## **Remarks**

This Response is provided in response to a non-final Office Action mailed June 2, 2004. The Office Action rejected claim 16 under 35 U.S.C. §102(b) as being anticipated by prior art, and claim 22 has been withdrawn from consideration and has been canceled by the Applicant. The Office Action further provided certain objections to the specification and drawings.

FIG. 17

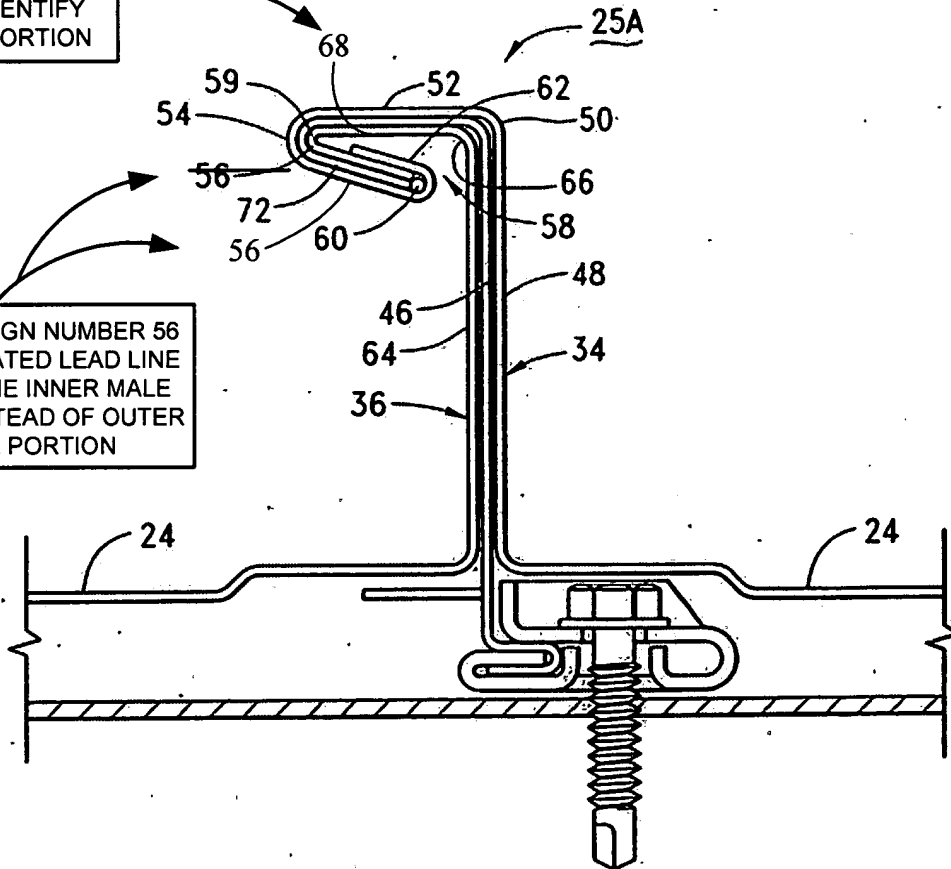
FIG. 13 has been amended to add reference numeral “98” as required by the Examiner. FIG. 17 has been amended to add reference numeral “68” and reference numeral “56” has been moved to show the outer female portion, instead of the inner male portion.

ADDED SIGN NUMBER 68  
 AND ITS ASSOCIATED  
 LEAD LINE TO IDENTIFY  
 THE FIFTH LEG PORTION

REPLACED SIGN NUMBER 56  
 AND ASSOCIATED LEAD LINE  
 TO SHOW THE INNER MALE  
 PORTION INSTEAD OF OUTER  
 FEMALE PORTION

FIG. 26

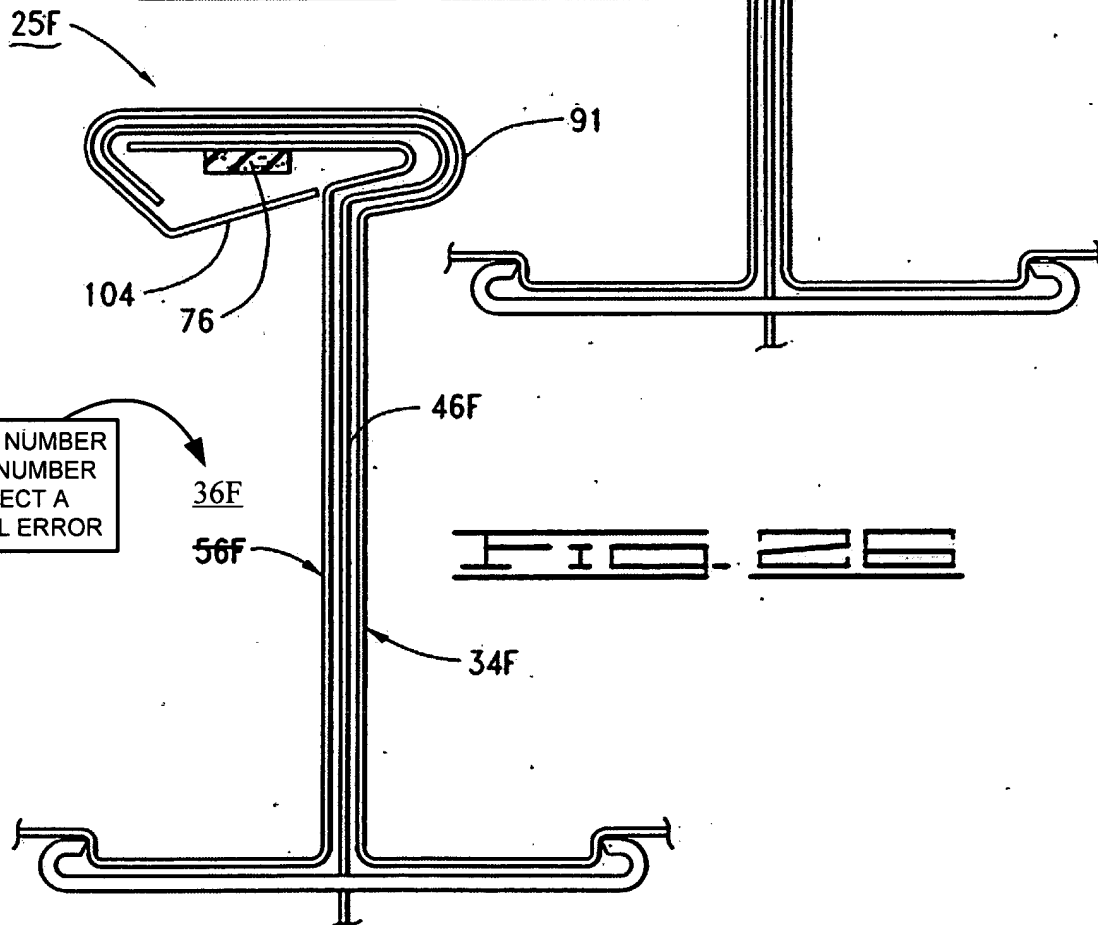
FIG. 26 has been amended to replace reference numeral “56F” with reference numeral “36F” to correct a typographical error.

The attached sheets of drawings include changes to FIGS. 13, 17, and 26. These sheets, which include FIGS. 13, 17, and 26, replaces drawing sheets 6, 7, and 11, which shows FIGS. 13, 17, and 26. FIG. 13 of drawing sheet 6, has been amended to include sign number 98, and its associated lead line, identifying the third radiused portion 98. FIG. 17 of drawing sheet 7, has been amended to show sign number 56, and its associated lead line, identifying the inner male portion instead of the outer female portion and to include sign number 68 and its associated lead line, to identify the fifth leg portion. FIG. 26 of drawing sheet 11, has been amended to show sign number 36F to correct a typographical error.
